## Technical product information

<b>Topic</b>	Convertible roof - C flap Bowden cable replacement
<b>Market area</b>	Worldwide Bentley (1WBE)
<b>Brand</b>	Bentley
<b>Transaction No.</b>	2033467/2
<b>Level</b>	EH
<b>Status</b>	Approval
<b>Release date</b>

Continual improvement in system designs can produce developments that may benefit older vehicles. One such development has been identified in the convertible roof mechanism. Re-route the C flap Bowden cable using a longer cable reduces the friction build up in the system and thus promotes smooth operation of the C flap and longevity in the system

Figure 3

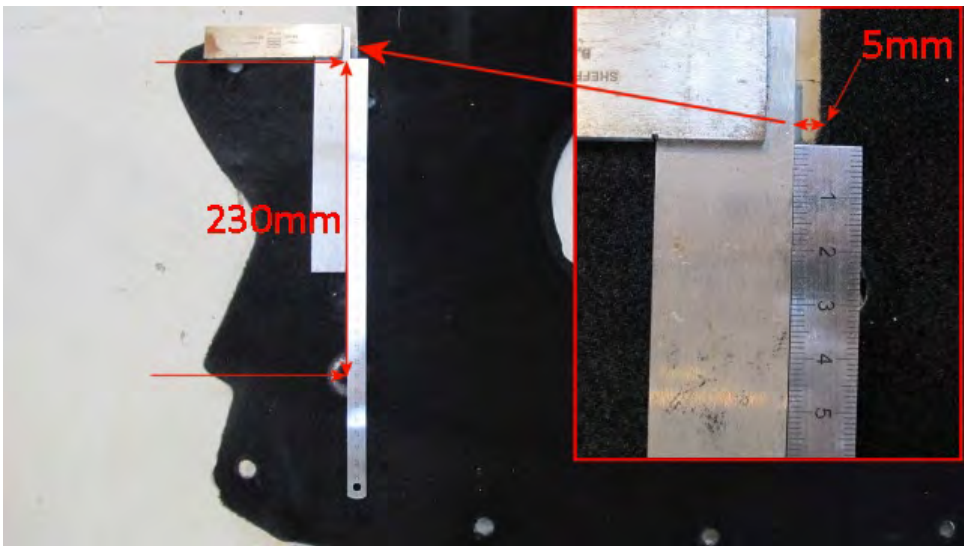
1. Produce two 30 mm holes in the tonneau carpet panel. Position each hole at 230mm along a line drawn 5mm out and at 90° to the vertical C flap cut out on the panel (see Figure 3, 4 and 5) Note in Figure 3 and 4 above the hole position has been highlighted by a white chalk circle
2. To fit the new longer re-routed cross over Bowden cable take into account the following operations in addition to the workshop manual procedure Rep. Gr 61 C flap Bowden cable – To remove and fit

Figure 5

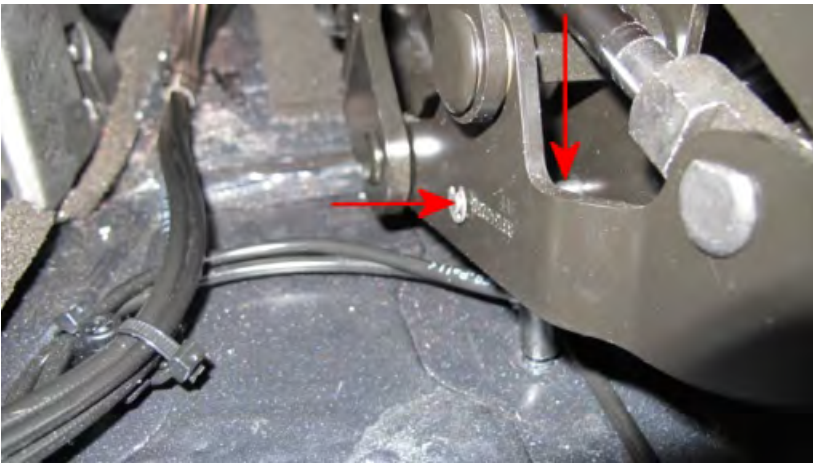
3. The pin securing the drive end of the Bowden cable can, for ease of assembly, be inserted in either direction (see Figure 5)

Figure 9

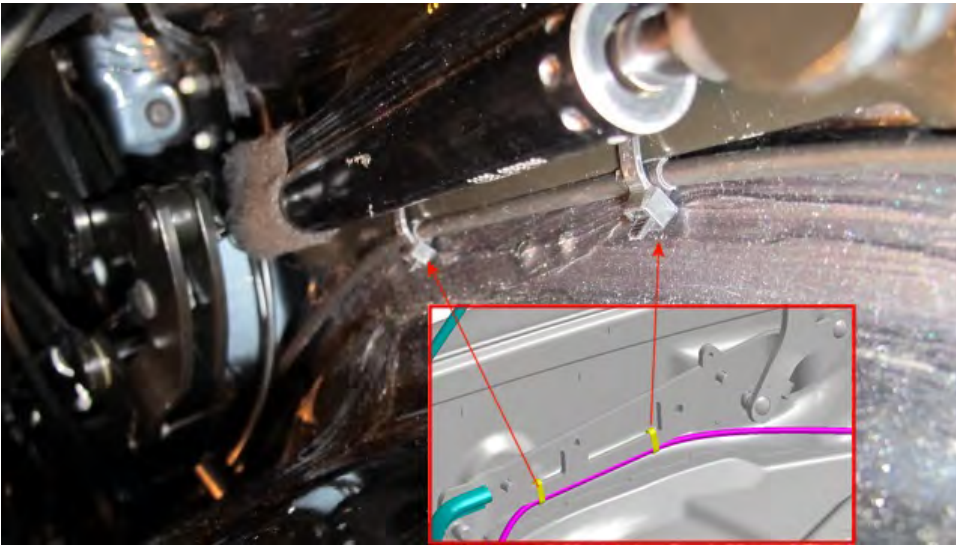
7. Start clipping the cables at the two new positions under the tonneau cover hydraulic ram as per TPI 2033508. Ensure the cable ties are placed at the points identified by the ring of black tape (see Figure 9)

Figure 10

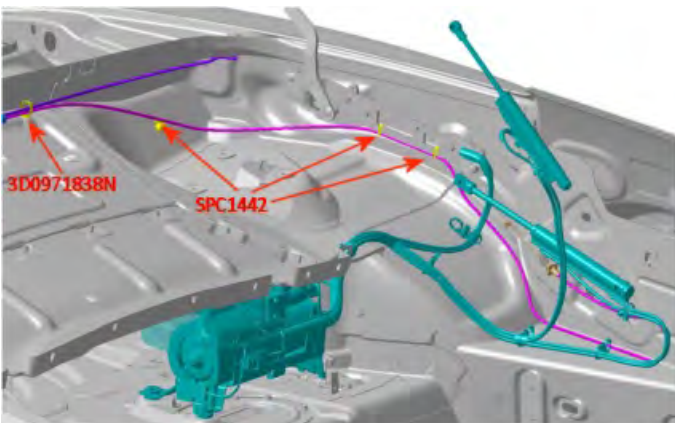
8. For each of the two new Bowden cables three SPC 1442 and one 3D0971838N cable tie are used in the locations shown in figure 10 and one original clip shown in figure 11, all other clips that were previously used to retain the Bowden cable must not be used and therefore can be removed and discarded (see Figure 9,10 and 11)

Figure 13

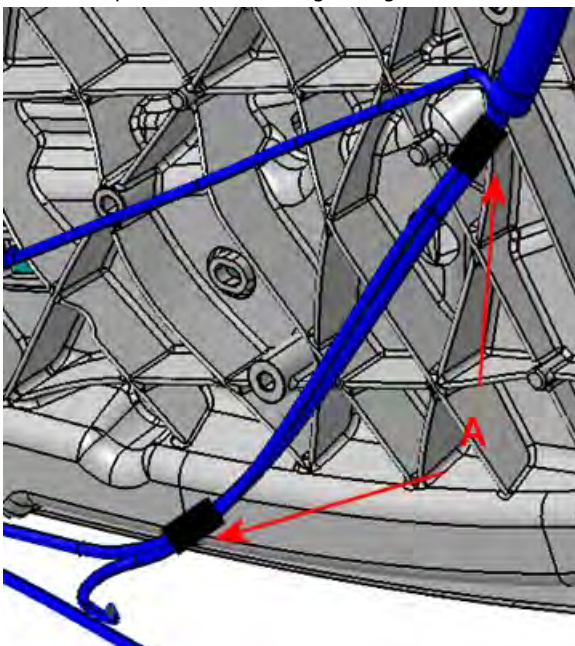
10. Disconnect the high mounted stop lamp cable at the body plug to enable it to be routed through the modified tonneau cover panel. Tape the high mounted stop lamp cable to the new Bowden cable at points (A) figure 13 then fit the longer cable obscuration sleeve (part number 3W7937115B) to the high mounted stop lamp supply cables before reconnecting the body plug (see Figure 14)
11. **Note:** If the obscuration sleeve, part number 3W7937115B is not available the original sleeve fitted to the vehicle can be used with the addition of a section of black tape

Figure 15

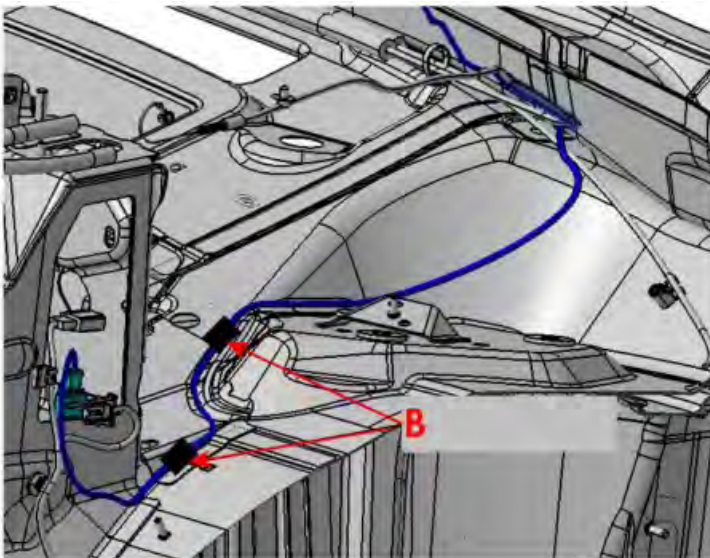
12. Follow the remaining refit procedure as contained in the workshop manual, taping down the high mounted stop lamp cable (B figure 15) to the painted body before fitting the new stowage compartment lower carpet (part number 3W7863479G) in the process (see Figure 16). Reference Rep. Gr 61 C flap Bowden cable – To remove and fit
